TITLE 24 PROPOSED PUBLIC POOL REGULATIONS

CALIFORNIA CODE OF REGULATIONS

TITLE 24

PUBLIC ~~SWIMMING~~ POOLS

FIGURE 31B-1

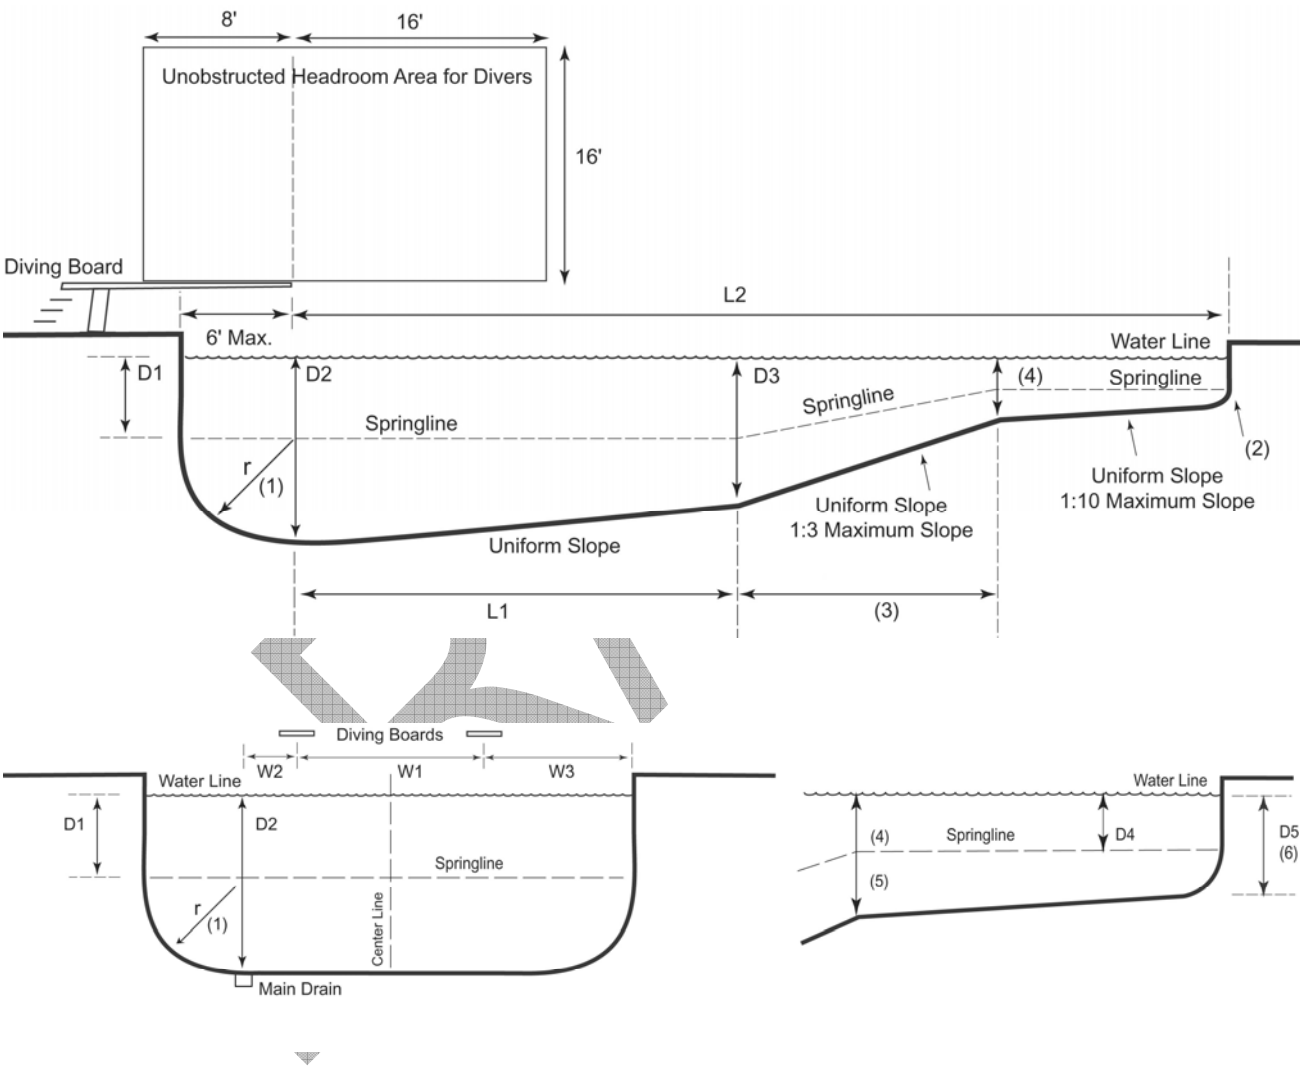
DEPTHS AND CLEARANCES FOR POOLS WITH DIVING BOARDS ~~ABOVE~~ GREATER THAN 30 INCHES (762 mm) ABOVE THE WATER LINE

FIGURE 31B-2

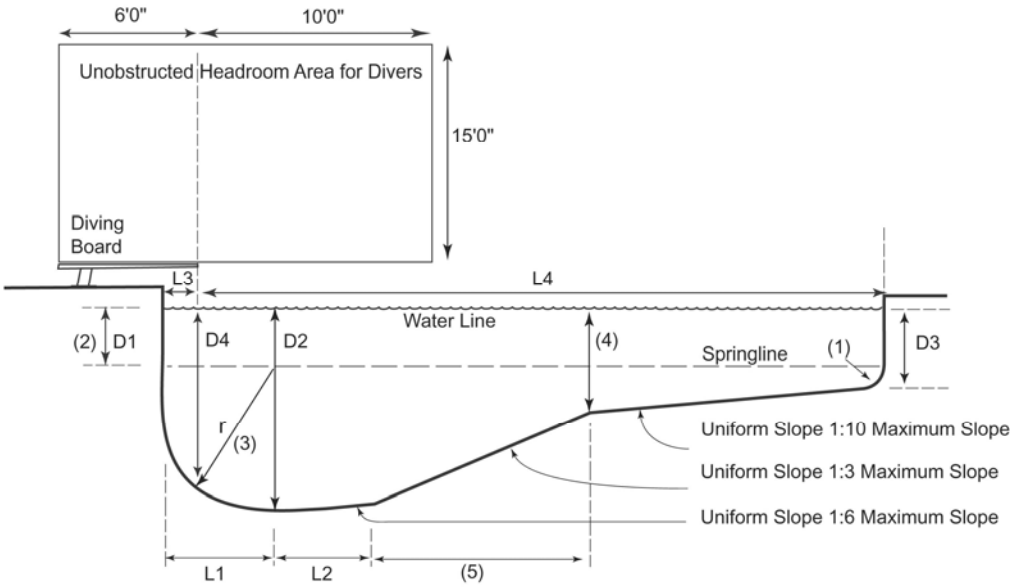
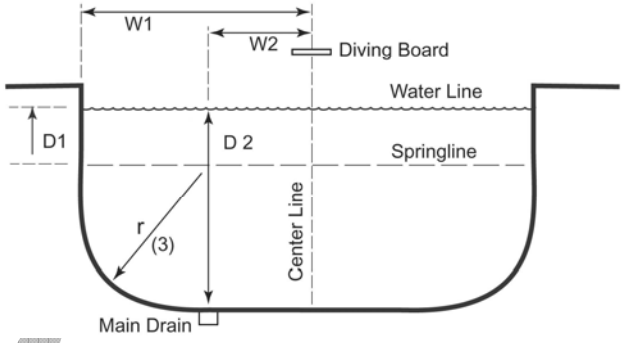
TRANSVERSE SECTION AT D2 ~~D-4~~

FIGURE 31B-3

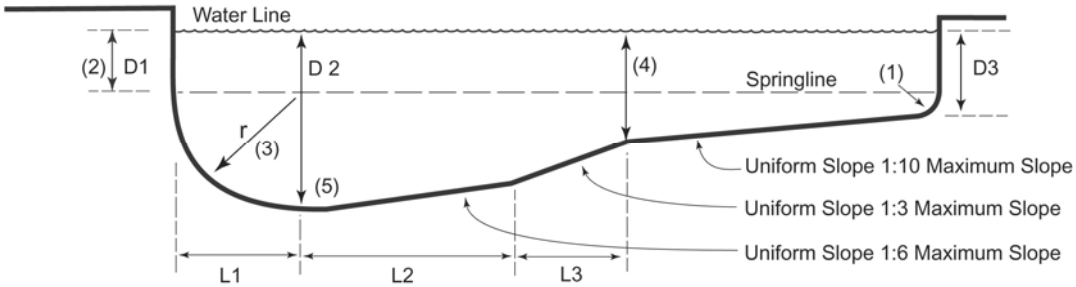
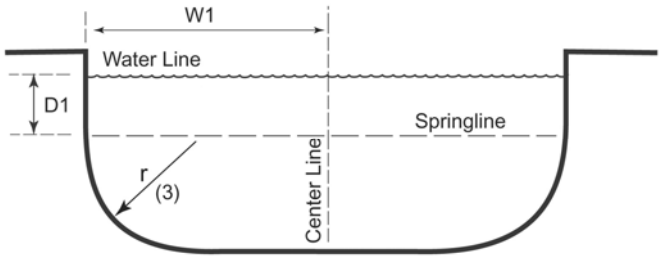
1. ~~Maximum r~~Radius at the shallow end shall be ~~1'0"~~ a minimum of 0’6” and a maximum of 1’0”.
2. Springline ~~(D1)~~ shall extend to the break in slope between the shallow area and the ~~diving bowl~~ deep area.
3. ~~See exception to Section 3108B.~~ Maximum radius shall equal D2 minus D1 dimensions.
4. ~~Width of pool at Section D-2 shall be at least 15' 0".~~ Where there is a break in slope, the break in slope shall be located at a water depth equal to 4’6”.
5. The main drain shall be located to provide complete drainage of the pool.
